JRPP No:	2013SYE033
DA No:	DA13/0270
LGA:	Sutherland Shire
Proposed Development:	First Stage of Residential Development including Demolition of Existing Structures, Construction of a Two (2) Level Podium Containing Car Parking, Communal Facilities and Commercial/Retail Tenancies, Three (3) Residential Flat Buildings above Podium Level Containing 220 Dwellings, Provision of Infrastructure and Services Including Access Roads, Associated Landscaping and Public Domain Works
Site/Street Address:	Lot 20 DP 529644 - 461 Captain Cook Drive, Woollooware
Applicant:	Bluestone Capital Ventures No.1 Pty Ltd
Submissions:	16 Objections
Recommendation:	Deferral of Decision
Report By:	Kylie Rourke, Environmental Assessment Officer - Planner Sutherland Shire Council

Figure 6 - Building floor plate variations

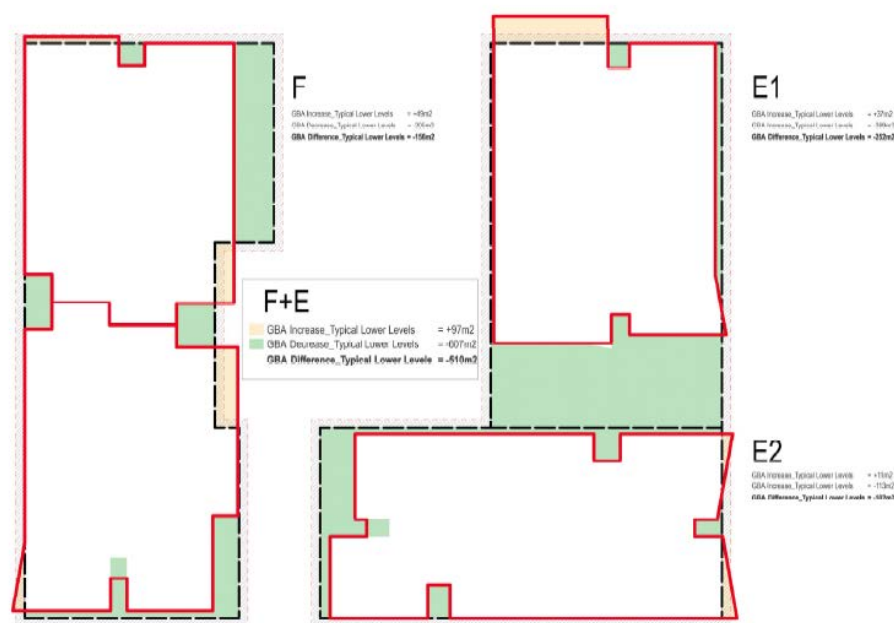
Council notes that the proposal is largely compliant with the Concept Plan, however as a result of the detailed design modifications; minor variations are proposed that extend beyond the approved building envelope. An example of these variations is illustrated in Figure 6 below.

The proponent has justified the variations on the basis that they provide additional articulation to the building and the additional roof height on building E1 masks the plant located on the roof.

The variations proposed are minor and are not considered to have a significant material impact. Despite the envelope protrusions, the proposed building volume is lower than the maximum building volume approved under the Concept Plan, as reflected in the maximum permitted GBA.
